P/OUT/2022/02496

Winterborne St Martin Paris Council are implacably opposed to any development which adds to our sewage load until such time as the infrastructure of the parish can cope.

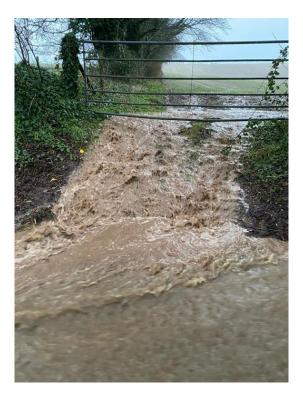
Flood mitigation is a secondary matter which must be fully explored within any proposal for the Valley. Flooding of the site is merely one part of this as we have recent evidence that the South Winterborne bridges in our village cannot cope with current let alone increased flows and the failure to cope results in flooding of the B1355 and near flooding of vulnerable properties.
